Appendix I of RNTPC
Paper No. A/YL-KTN/907A

APPLICATION FOR PERMISSION
UNDER SECTION 16 OF
THE TOWN PLANNING ORDINANCE
(CAP.131)

Proposed Temporary Warehouse (Excluding Dangerous Goods Godown) with Ancillary Facilities for a Period of 3 Years and Associated Filling of Land

(S.16 Planning Application No. A/YL-KTN/907)

Drawing Title	Date
DRAINAGE PROPOSAL	6.3.2023
Scale of A4	Date
1 : 200	
Drawn	
Revised

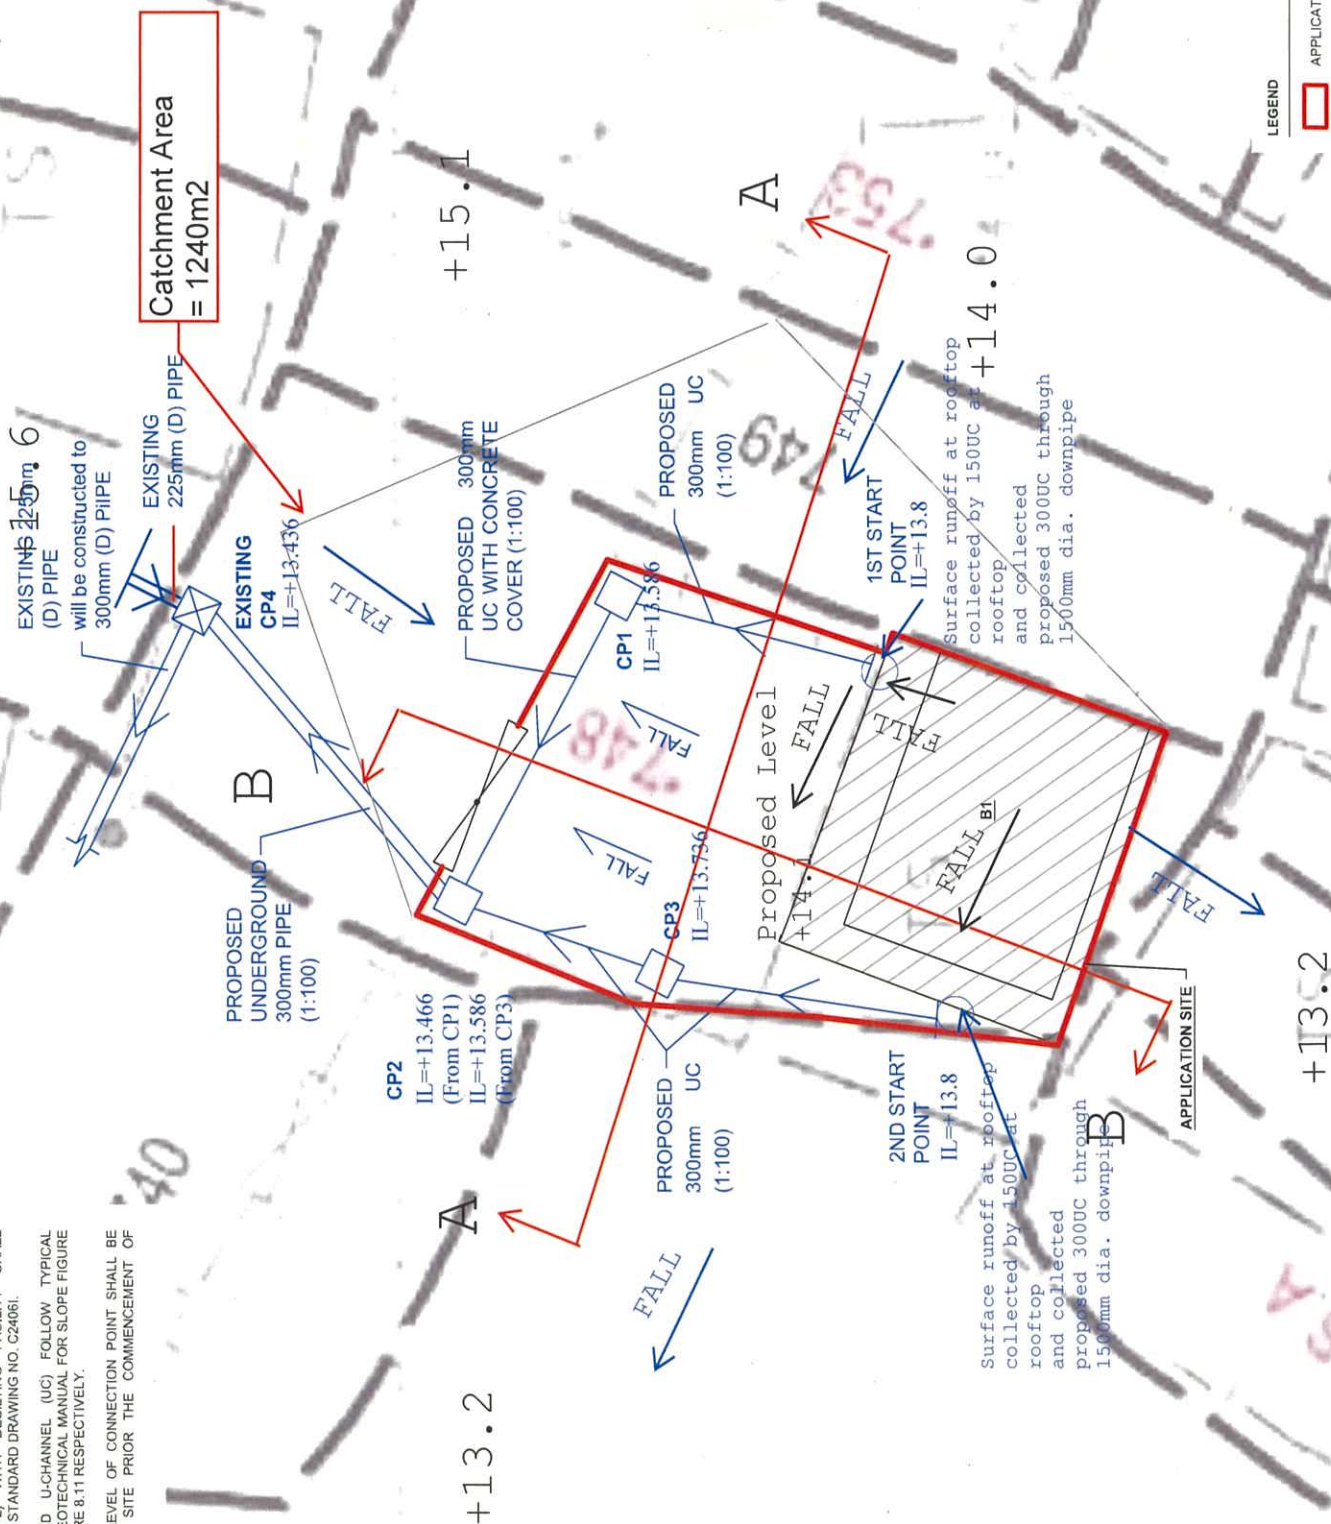
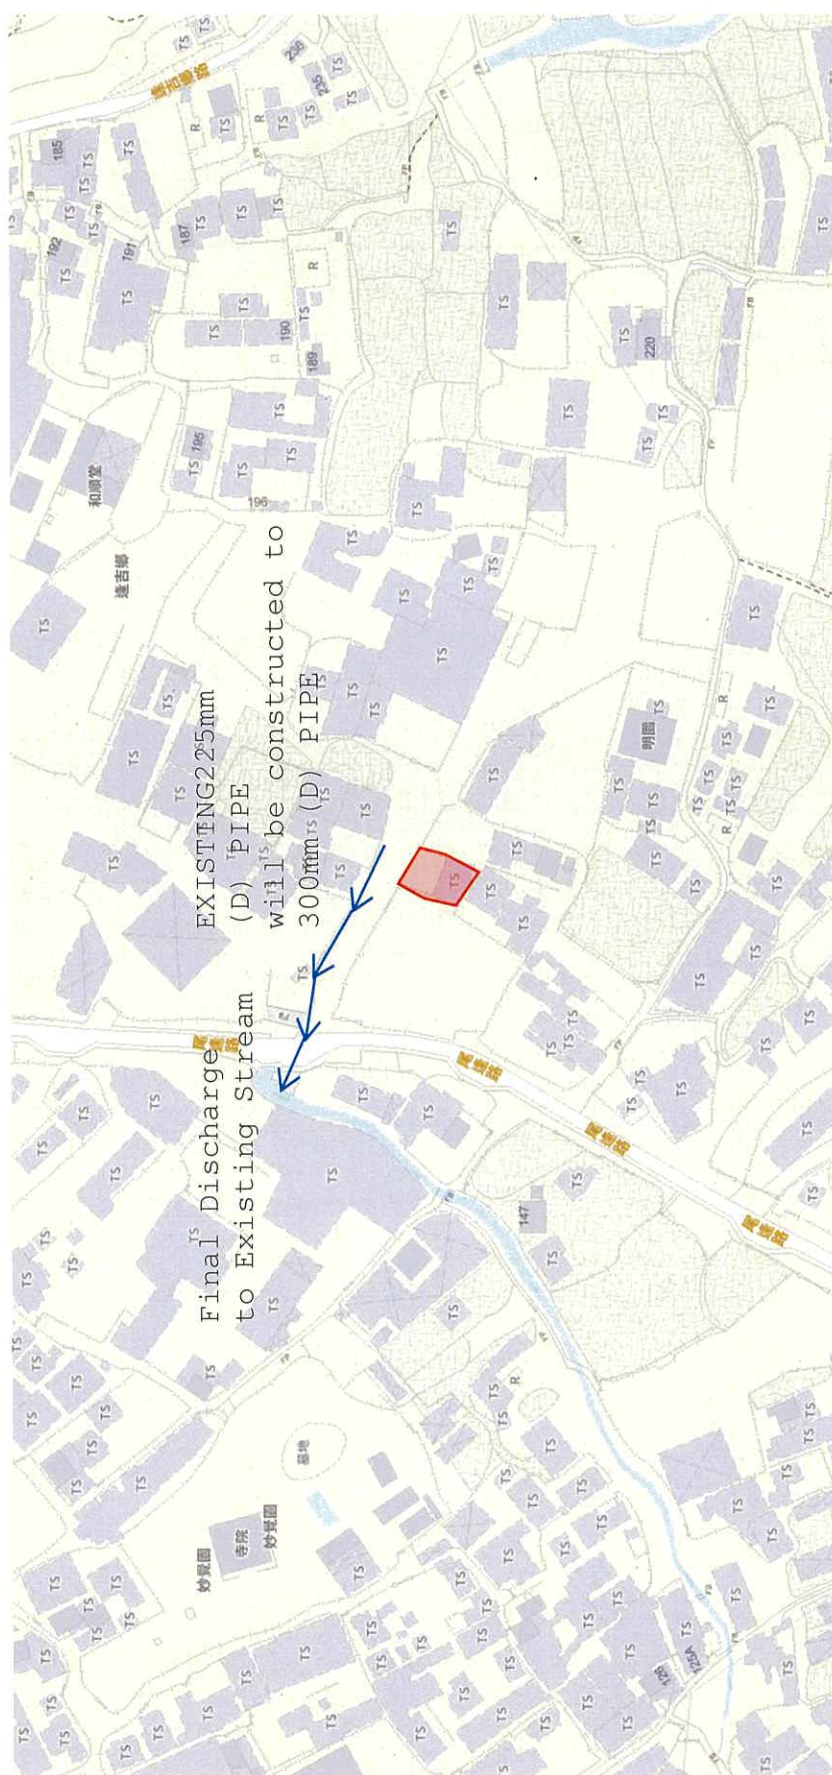
2. Comments of Chief Engineer/Mainland North, Drainage Services Department (Contact Person: Mr. Terence TANG; Tel: 2300 1257)		
(a)	RtC (a): Section A-A is wrongly presented the proposed site situation. The land filling will affect the overland flow across the site. Please review your proposal.	A revised drainage proposal is provided (Annex II). Cross-Section is revised. Also, Cover level of UC and Catchpit at eastern is proposed as +14.0mPD for collect surface runoff.

(d)	RtC (d): Please indicate (1) another I.L. of CP2 (2) I.L. of 2 Start Points on drainage plan.	It is provided accordingly (Annex II).
(e)	CP1's I.L. is higher than Start Point 1's I.L. which is unacceptable. CP1's I.L. does not match with the catchpit schedule. Please revise.	It is provided accordingly (Annex II).

Proposed Catchpit/Start Point	Cover Level (mPD)	Invert Level (mPD)
Start Point 1	+14.0	+13.7
Start Point 2	+14.1	+13.8
CP1	+14.0	+13.586
CP2 (With Desilting Facility)	+14.1	+13.466 (From CP1) +13.586 (From CP3)
CP3	+14.1	+13.736
Existing CP4	+15.7	+13.436

Figure 8.7 - Chart for the Rapid Design of Channels

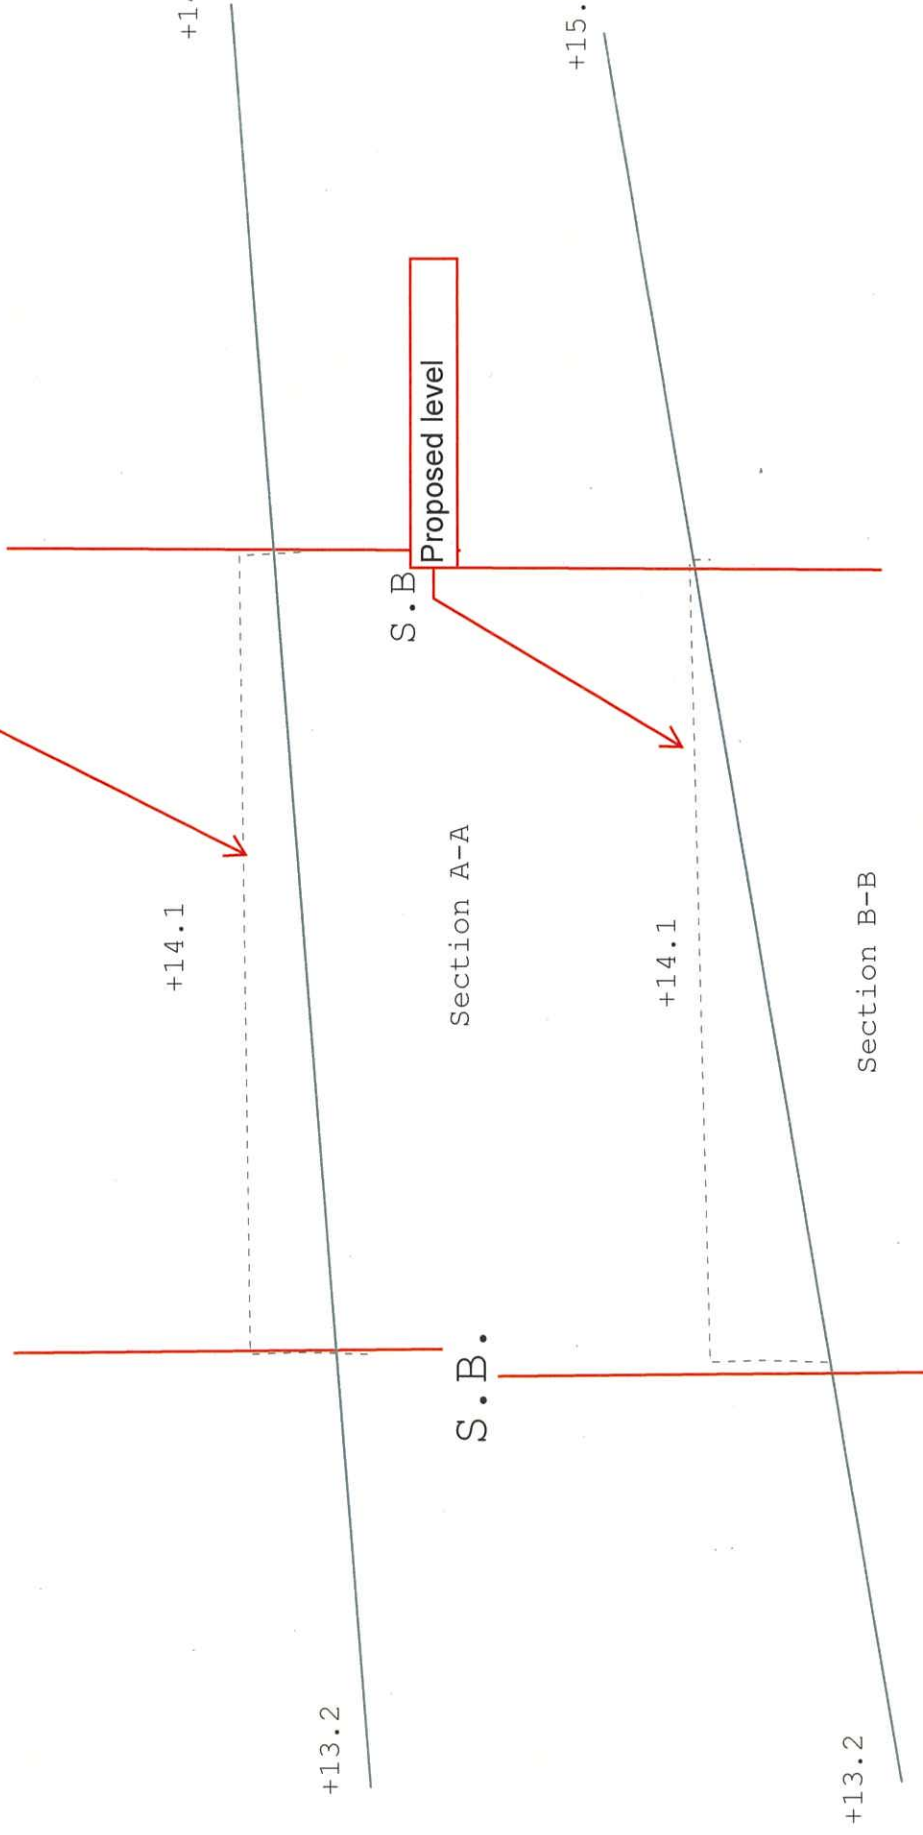
(b)	RtC (b): In calculation, 225UC should read 300UC.	It is revised accordingly.
(c)	RtC (c): Please provide roof drainage system for comment. In general, peripheral channels should be provided.	Cross-section is provided accordingly. Roof peripheral channels are provided.

According to (Figure 8.7 - Chart for the Rapid Design of Channels),
For gradient 1:100, 300UC will be suitable for the site

SITE PHOTO

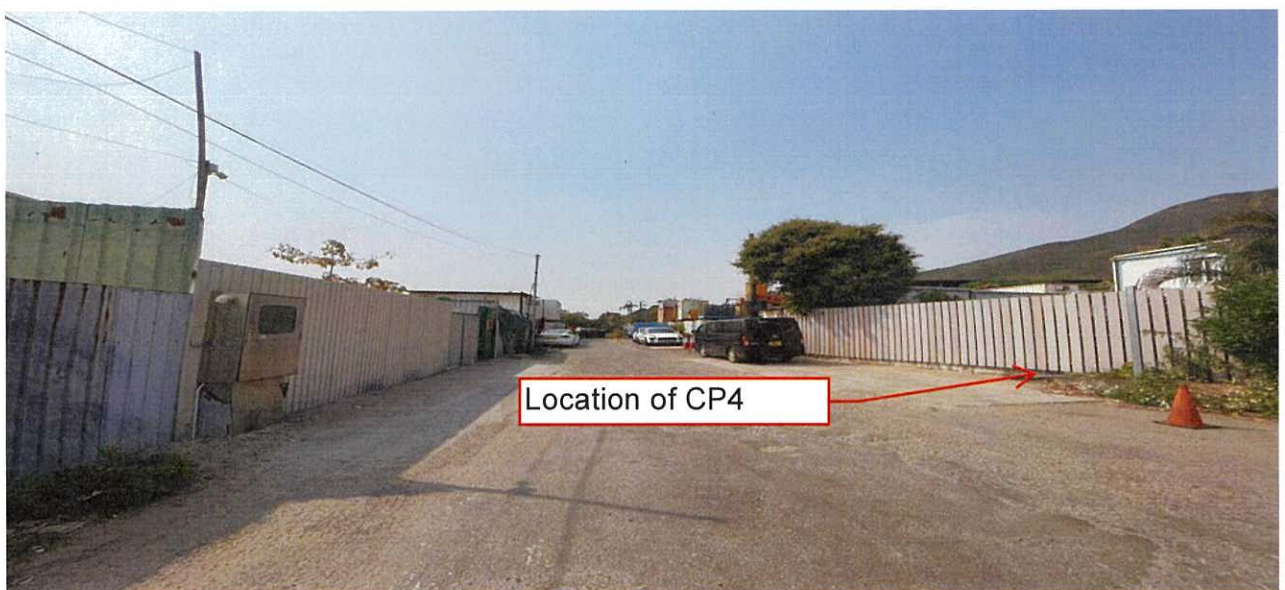
(f)	RtC (g): In calculation, please provide reference of A/YL-KTN/605 for its runoff.	A/YL-KTN/605 drainage proposal is attached for your reference.
(g)	RtC (i): Noting that the existing 225mm dia. UPVC will be reconstructed to 300mm dia. UPVC. Please show the full alignment of the proposed works with photo record supported.	It is provided accordingly

Existing Condition of CP4
